Addendum 02
2022 Bond
Painting Project Districtwide
Package A
Package B

Pasadena ISD
CSP#26P-040LP

22 May 2026

This addendum modifies the original Bid Proposal Documents dated April 29, 2026 and forms a part of the Contract Documents.

Sheet
A2

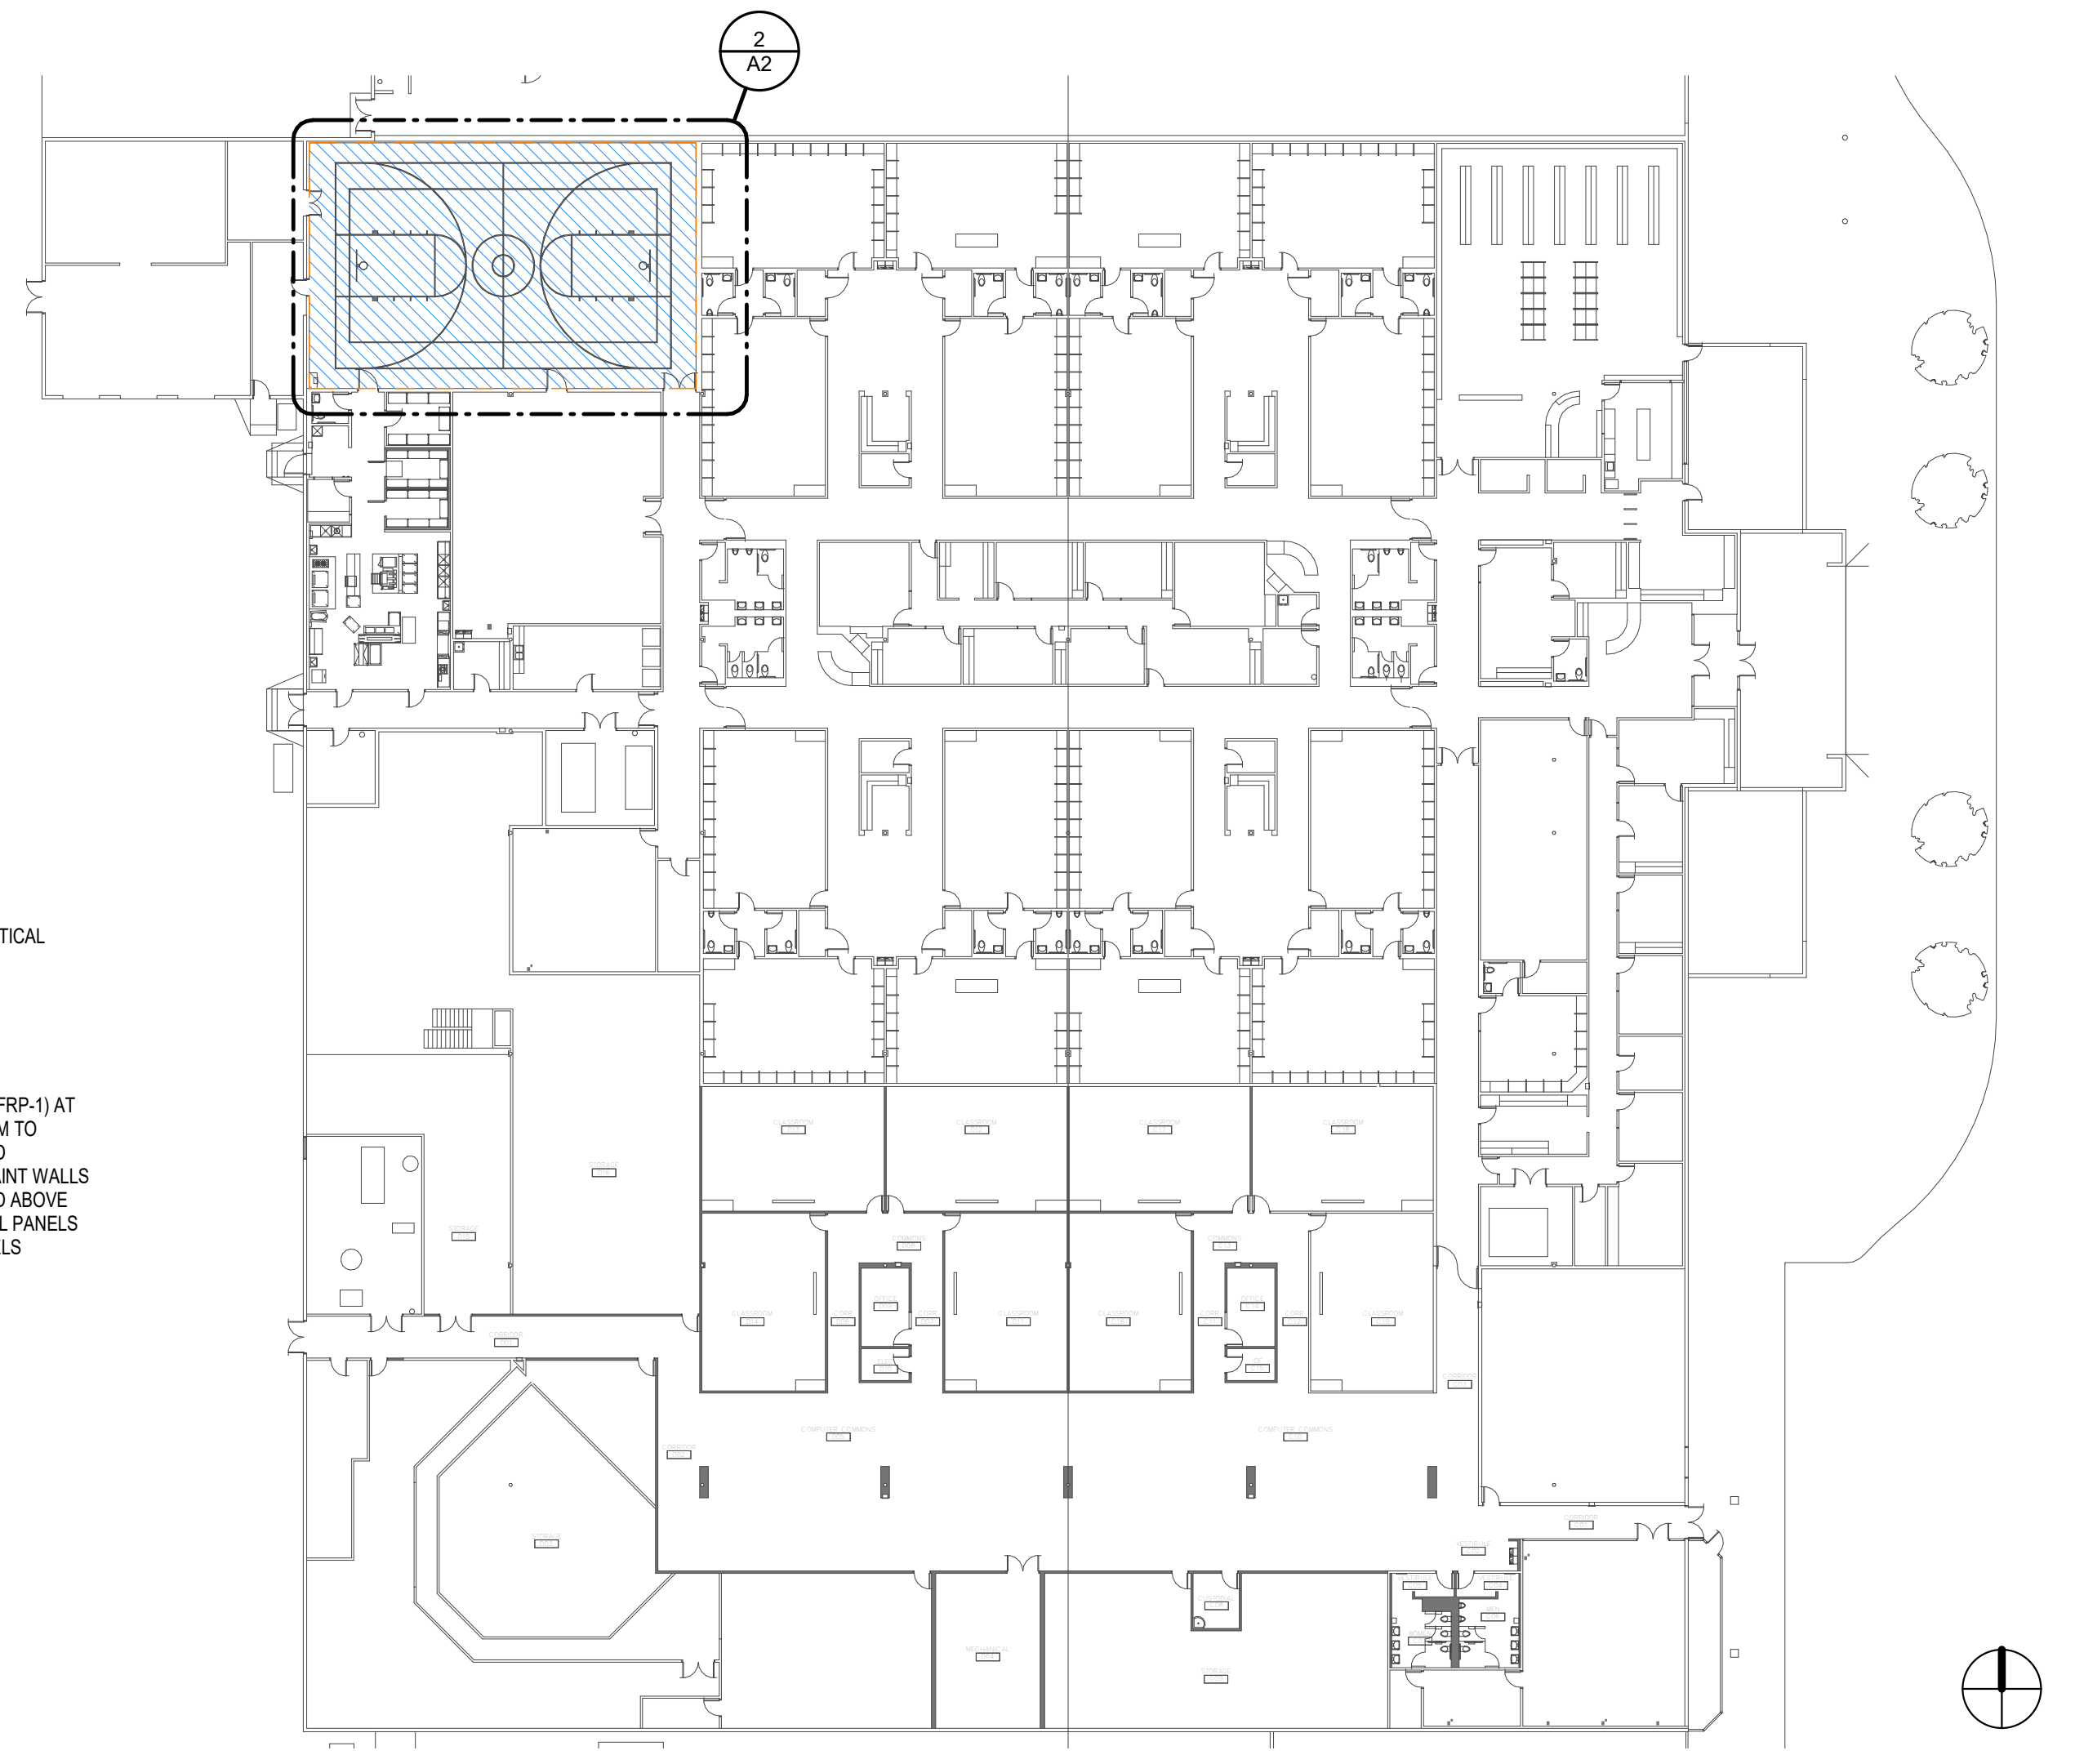
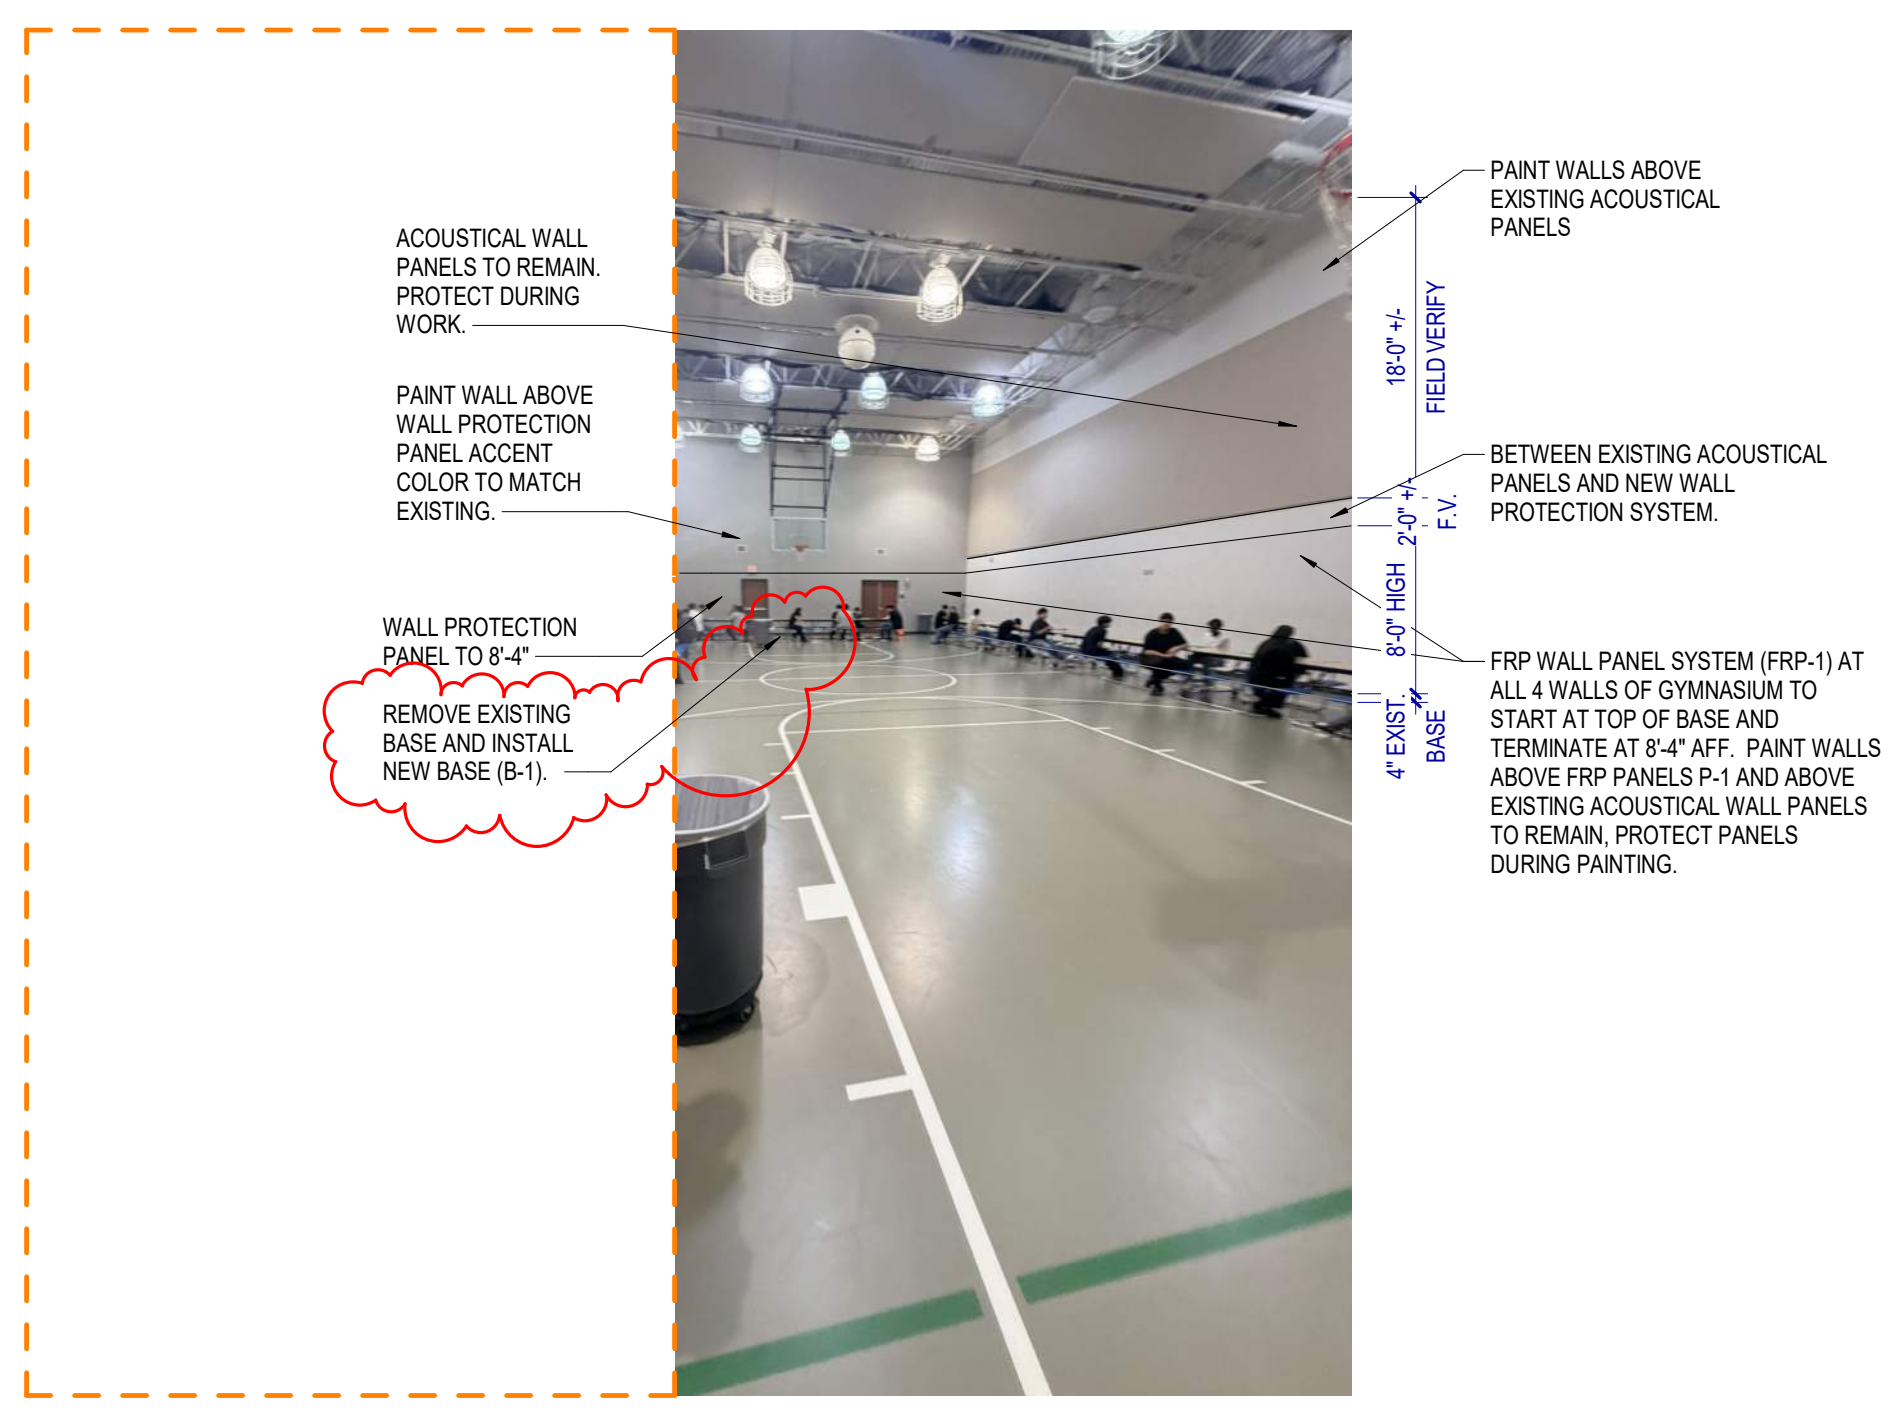
- 01 A1 – Sullivan Middle School: Replace with Revised Sheet A1.
 - a. Paint Classroom Walls, Hollow metal door and window frames in Classrooms
- 02 A2 – The Summit Replace with Revised Sheet A2.
 - a. Remove existing base in Gymnasium and provide new base to match existing.
 - b. Paint Hollow Metal Door and Window frames on both sides, Typical.
- 03 A3 – De Zavala Middle School Replace Revise Sheet A3.
 - a. Remove vinyl wall covering in classrom wall, Paint P-1.
 - b. Paint Gymnaisum walls and steel structure to existing Metal Wall Panel height.
 - c. Paint Dining room cmu walls and steel structure to existing Metal Wall Panel height. Paint background of existing wall graphics. Existing wall graphics to remain.
 - d. Replace Revise sheet A3.
- 04 A4 – Jackson Intermediate School: Replace with Revised Sheet A4
